UNITED STATES PATENT AND TRADEMARK OFFICE

APPLICATION NO.	FILING DATE	FIRST NAMED INVENTOR	ATTORNEY DOCKET NO.	CONFIRMATION NO.
10/821,429	04/09/2004	David W. George	T-4358	1238
42556	7590	08/10/2005	EXAMINER	
CHARLES H. THOMAS CISLO & THOMAS LLP 4201 LONG BEACH BLVD SUITE 405 LONG BEACH, CA 90807-2022			LANGDON, EVAN H	
			ART UNIT	PAPER NUMBER
			3654

Office Action Summary	Application No. 10/821,429	Applicant(s) GEORGE ET AL.	
	Examiner Evan H. Langdon	Art Unit 3654

FIG. 1

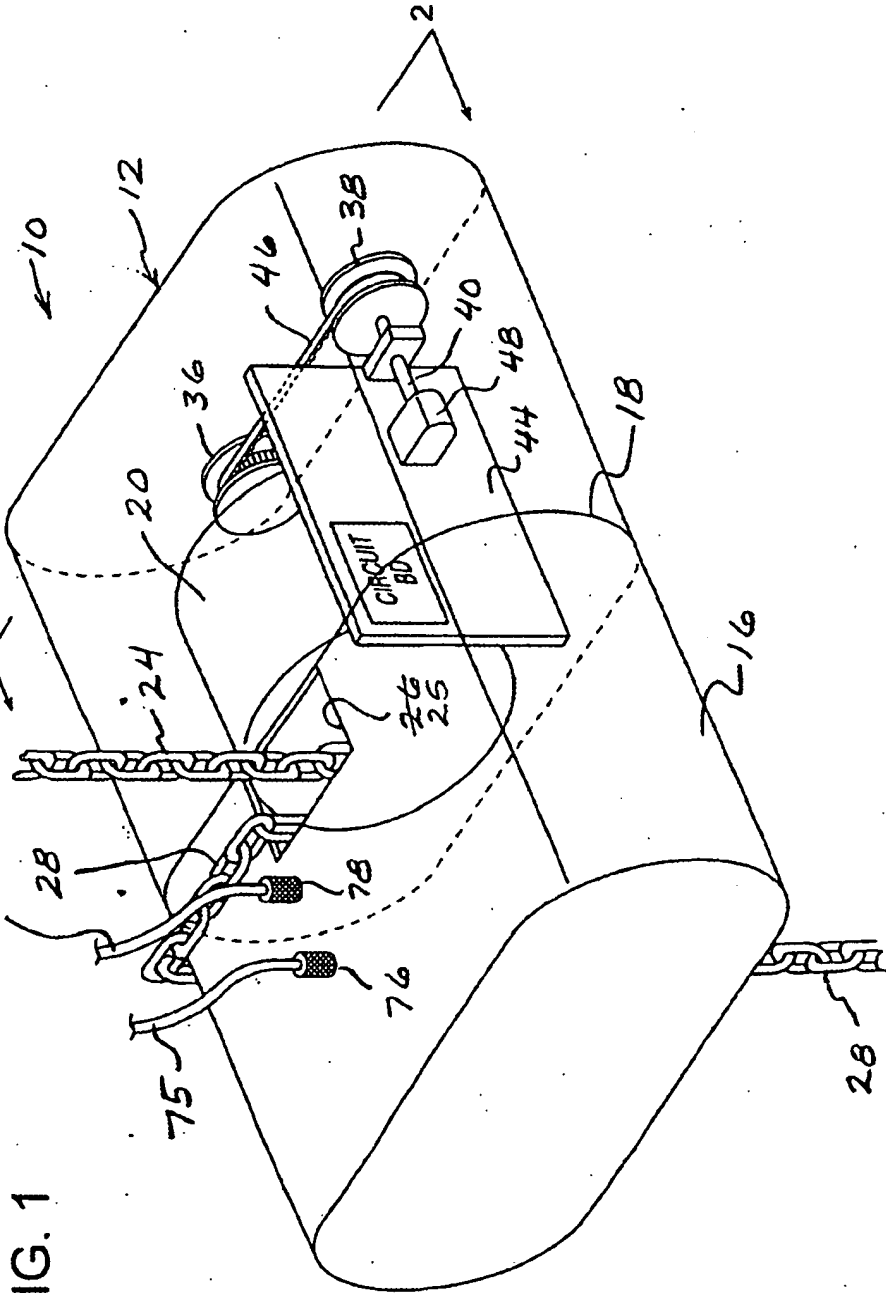
The cross-out of reference 26 numeral and writing the reference numeral 25 is inappropriate.

Do Not
Enter
7/24/05
[Signature]
